**From:** Heather Mitchell  
**Sent:** Thursday, January 13, 2022 11:45 AM  
**To:** Brian Stanley; Mike Cugnetti  
**Subject:** FW: [External]:Re: [External]:Re: [External]:Re: P&A COA (05-001-06996)

We have another re-entry P&A. The approved P&A form 6 has a COA that states we are within ½ mile of the Bald Eagle Nest and we must consult with CPW. However we are outside the ½ mile buffer. I just wanted to confirm with you that this COA is not necessary for this particular location.

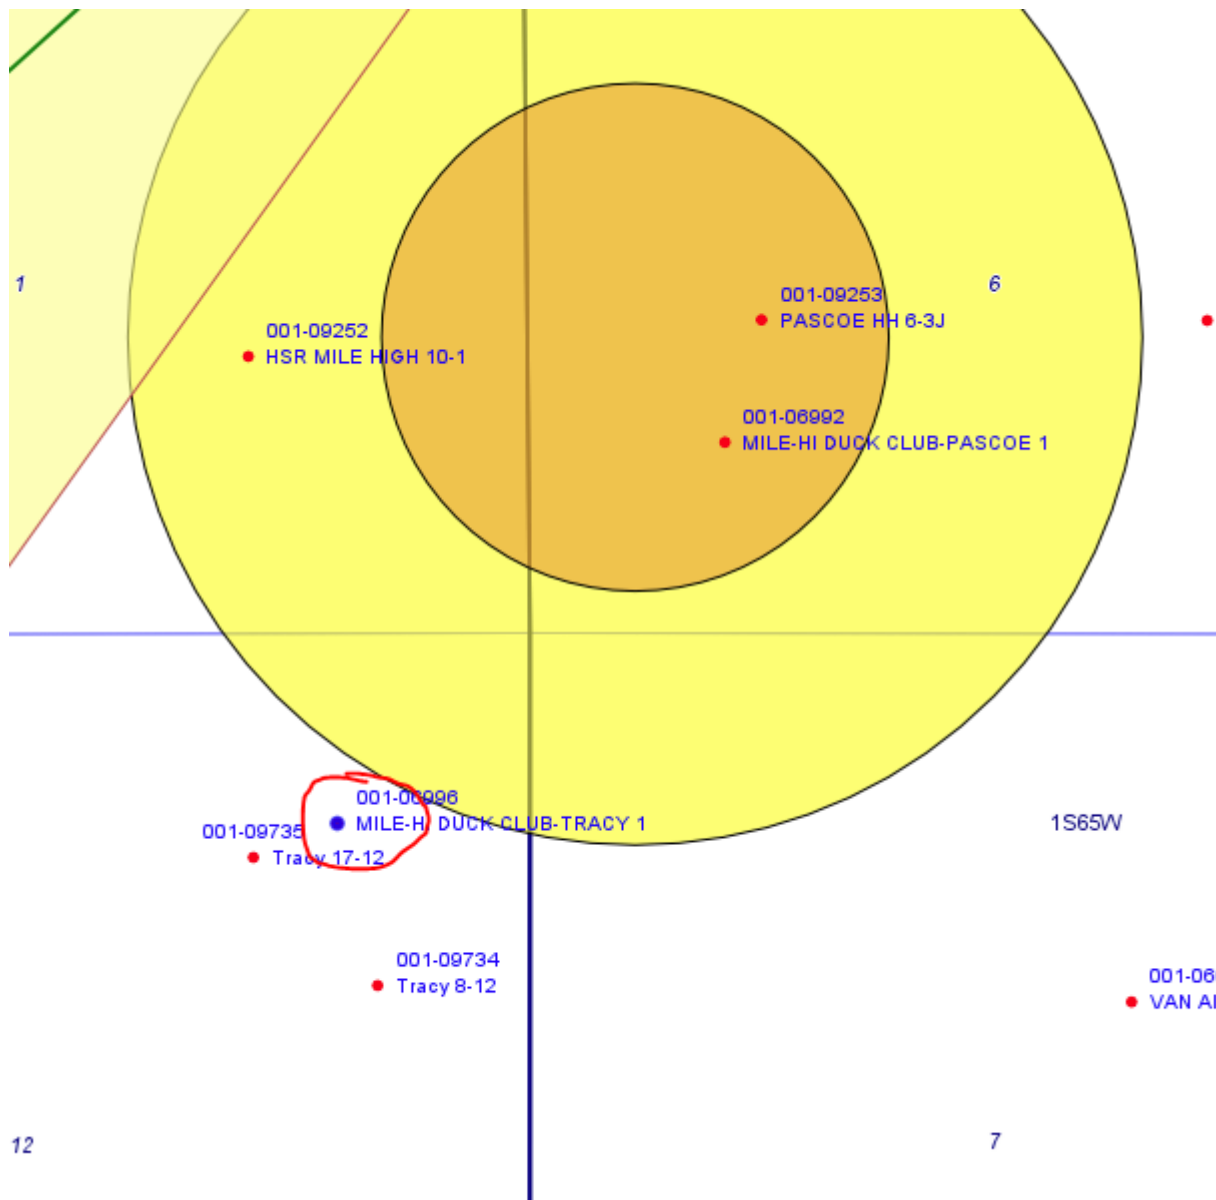
Yes our access road is outside of the buffer as well. I have loosely drawn it in below.

At first glance, the location does not appear to need a COA, but can you confirm the access road isn't in the buffer either? (e.g., meaning a new access road would need to be constructed within the buffer)

Please see the below screen shot of the ¼ mile buffer and the ½ mile buffer and our P&A well (Mile-HI Duck Club-Tracy 1 05-001-06996). Please let me know if you need anything from us on this.

Yes, I agree no COA is needed. If COGCC disagrees, please have them contact me.
